**August 15, 2014**

**Field Update Notice # 74B253  
Hercules CAFS Hydraulic Hose**

<b>Pirco Manufacturing Inc.</b> 10000 15th Street Dallas, TX 75244 (972) 241-1111 FAX (972) 241-1112 WWW.PIRCO.COM
<b>SCHEMATIC, CAPS, HYDRAULIC</b> 1877949	PART NO. DATE REV. QUANTITY UNIT DRAWN BY CHECKED BY APPROVED BY DATE

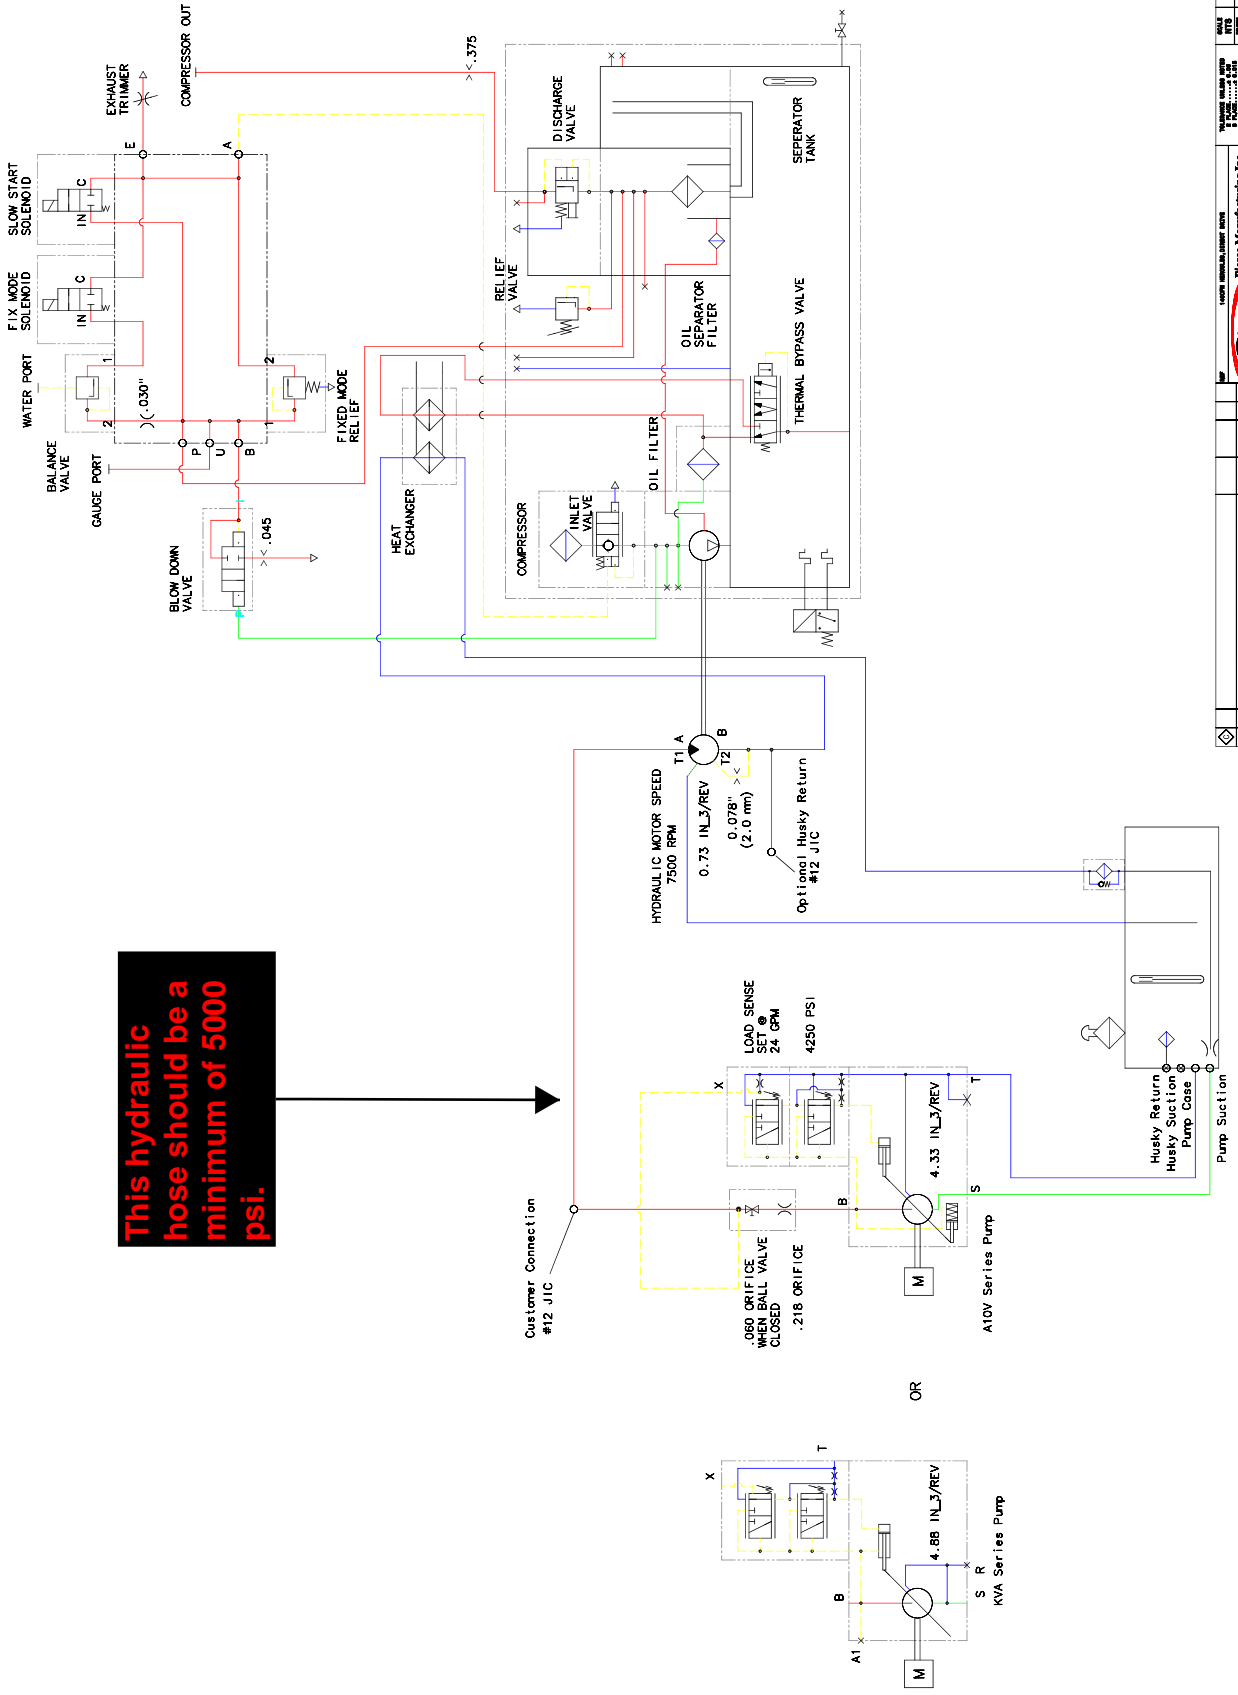
Vehicles may have shipped with a hose rated less than 2000 psi in a location which should have a 5000 psi rated hose. The hose could burst, causing hydraulic fluid to be expelled under high pressure. Units affected by this campaign were built at the Pierce Mfg Florida Division between April 2013 and July 2014.

**This hydraulic hose should be a minimum of 5000 psi.**

- Dealer is to inspect the hose from the pump to the motor to determine whether the correct PSI rated hose is installed (see attached diagram)
- If the hose is incorrect, the dealer will measure the hose and email length to [campaigns@piercemfg.com](mailto:campaigns@piercemfg.com)
- Pierce will supply a new hydraulic hose for dealer to install
- Pierce will pay 0.5 hour to inspect and measure hose
- Pierce will pay 1.5 hours to replace hose if needed
- Pierce will pay 2.0 hours travel if replacement is not required, 4.0 hours if replacement is required
